MINUTES OF THE MEETING March 20, 2008

Seattle Design Commission

Projects Reviewed

Urban Mobility Plan
Fire Station 35 – Crown Hill
Fire Station 30 – Mount Baker
Councilmember Richard Conlin
Capitol Hill Station ST University Link

Figure 7: Art piece

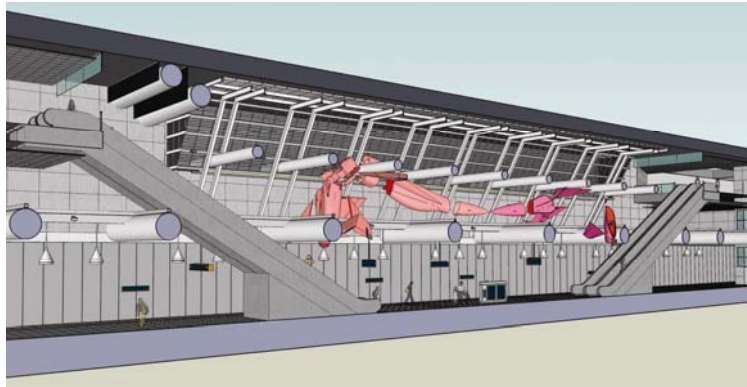
- The materials palette seems reserved and somewhat institutional and may benefit from a more dynamic color scheme.
- Some panel members expressed a concern for the use of warplanes in art piece in the context of a light rail station. While we appreciate the artist's intention of expressing fluid movement and natural forms, the relationship between natural form and a fighter plane as presented is questionable. A solution may be an artist statement prepared for the next presentation to clarify the appropriateness of the art in the station.

Note: Preliminary vote included four dissenting votes based on the character of the surface buildings, the dislike of the art piece, and the unclear relation of the project to the future TOD.

- Other ways planes penetrate architecture that is not so offensive?
 - Urge great care in emphasizing poetry of forms in people's minds. Notion of destruction is there in the fighter jets, but the entire form after deconstruction of the pieces is holistic. The piece is not meant to convey aggression.

- Chosen a provocative art piece. Planes may be appropriate with everything that is going on in area and the neighborhood.
- Concern over violent ramifications of art piece. Appreciate that the art seeks to connect important "Seattle qualities" of nature and technology into this piece, but question the use of a fighter jet as the manifestation of those ideas. Encourage further reflection on this, and preparation of an artist's statement for review next time.
